## September 3, 2019 Zoning and Platting Commission Agenda Q & A Report

### Site Plan Correction Request

Project Name: Echelon 1 & 2 Office Site

### Echelon I & II Office Site – 9430 Research Boulevard City of Austin Site Plan Case No. SP-2014-0414B Storm Water Quality Pond Volume Calculations

Sheet **3** of **19**

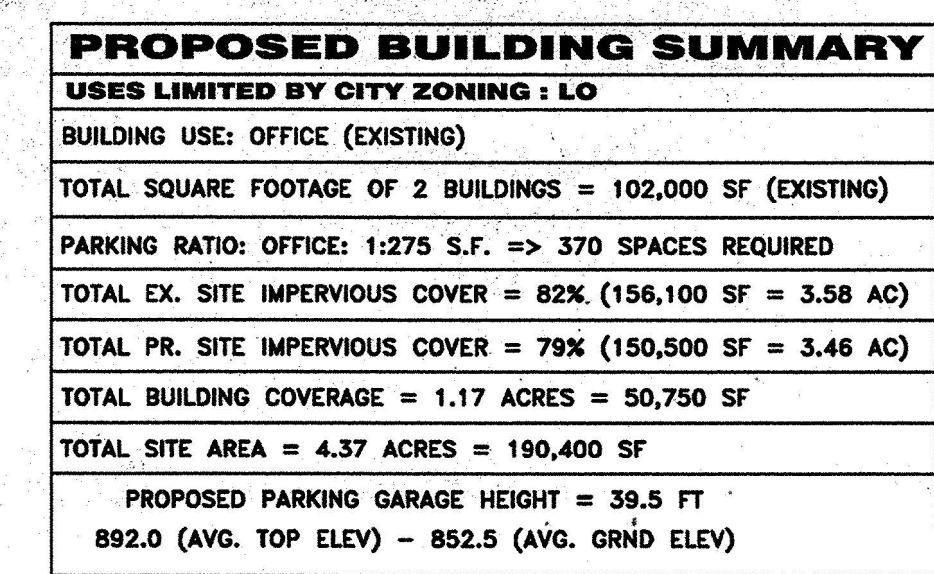
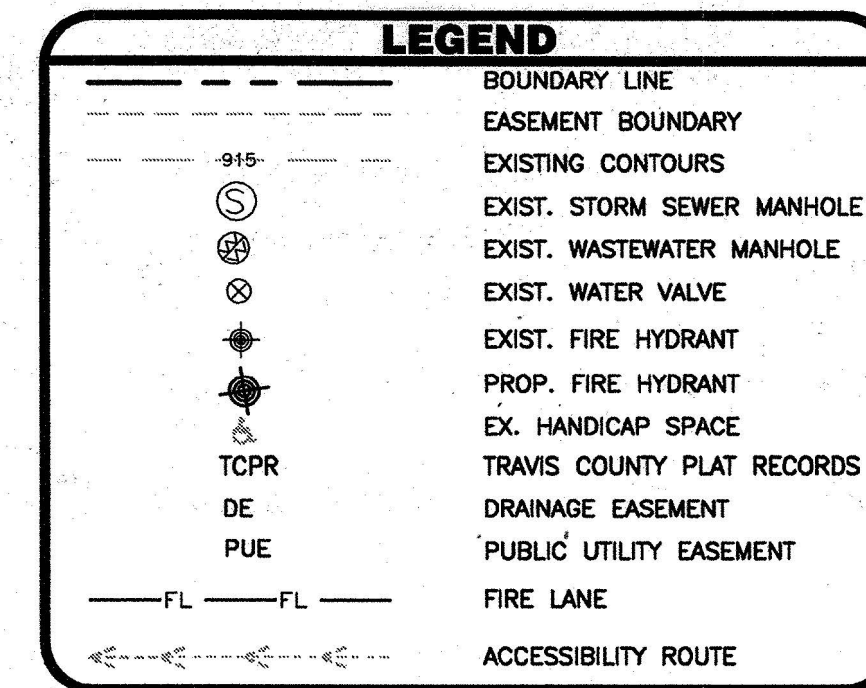
Modified Proposed Fire Hydrant Location Based On Field Conditions. Revised Storm Water Quality Pond Wall And Volume Based On Slight Change In One Pond Wall.

As we discussed, the storm water quality pond volume provided will be reduced very slightly with this proposed site plan correction. The current water quality volume provided is 2,895 cubic feet (based on the original pond design). The water quality volume provided after the proposed modification will be 2,801 cubic feet (a 94 cubic foot reduction). The volume provided with the proposed site plan correction will still be greater than the required water quality volume, which is 2,360 cubic feet. Pond volume calculations showing these numbers in detail are enclosed. The site plan sheet with the pond volume information has been modified and is attached.

#### Correction 2 Plan Volume

<i>Elevation</i>	<i>Area (Square Feet)</i>	<i>Volume (Cubic Feet)</i>	<i>Summation of Volume (Cubic Feet)</i>
842.7	501	0	0
842.9	625	113	113
844.0	625	688	801
845.0	625	625	1,426
846.0	625	625	2,051
847.0	625	625	2,676
847.2	625	125	2,801

Water Quality Volume Required = 2,360 Cubic Feet < 2,801 Cubic Feet Provided
